APPLICATION NO.	FILING DATE	FIRST NAMED INVENTOR	ATTORNEY DOCKET NO.	CONFIRMATION NO.
10/622,042	07/17/2003	Bo Su Chen	15436.441.7	2261
22913 7590 07/30/2007 WORKMAN NYDEGGER (F/K/A WORKMAN NYDEGGER & SEELEY) 60 EAST SOUTH TEMPLE 1000 EAGLE GATE TOWER SALT LAKE CITY, UT 84111			EXAMINER ROJAS, OMAR R	
			ART UNIT 2874	PAPER NUMBER
			MAIL DATE 07/30/2007	DELIVERY MODE PAPER

Office Action Summary	Application No. 10/622,042	Applicant(s) CHEN ET AL.	
	Examiner Omar Rojas	Art Unit 2874

DETAILED ACTION

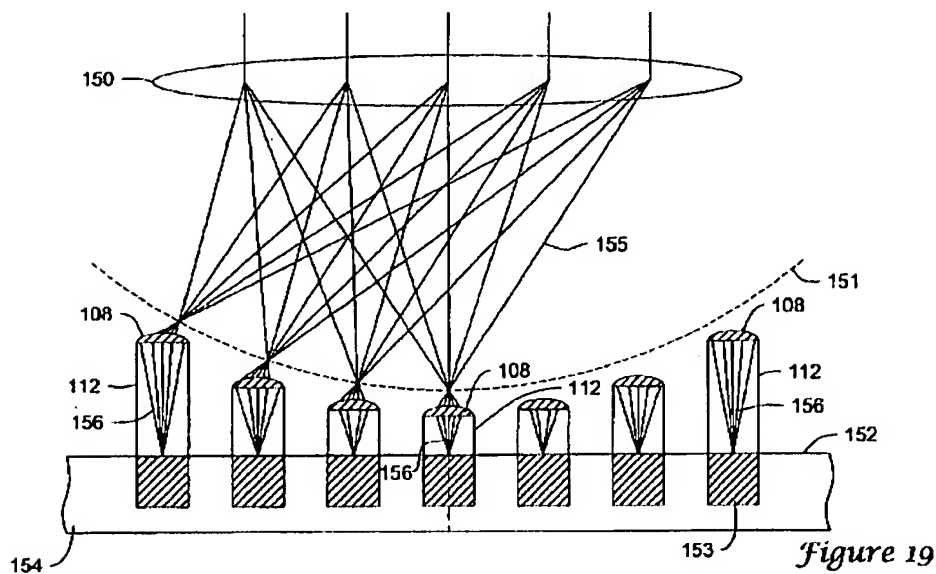
In re claims 1, 13, and 27, Liu discloses an optical coupling system (e.g., Figures 19-20) comprising:

a substrate **154** having a plurality of optoelectronic elements **153** formed on said substrate;

a plurality of posts **112** formed over the plurality of optoelectronic elements **153** on said substrate wherein each post has a height of between about 30 microns and about 250 microns (see Fig. 11a; col. 12, lines 24-34; and col. 13, lines 8-10);

a plurality of microlenses **108** with each lens **108** formed on a first end of said posts **112**, wherein the microlenses have a diameter of between 20 and 60 microns (col. 13, lines 8-10);

a fore optic/window/substrate **150** having a first side proximate to said plurality of microlenses and having a second side. A particular coupling efficiency is inherently achieved in Liu because the distance between fore optic **150** and microlens **108** is the same as the distance specified by claim 1 and the distance between the second side of fore optic **150** and the optoelectronic component **153** is the same as the distance specified by claim 27. Furthermore, a particular coupling efficiency is also achieved by Liu because the thickness of posts **112** and the height and radius of lens **108** is the same as the thickness, height, and radius specified by claim 25. Figure 19 of Liu is reproduced below.

In re claim 2, the particular limitations are shown in Figure 19 of Liu.
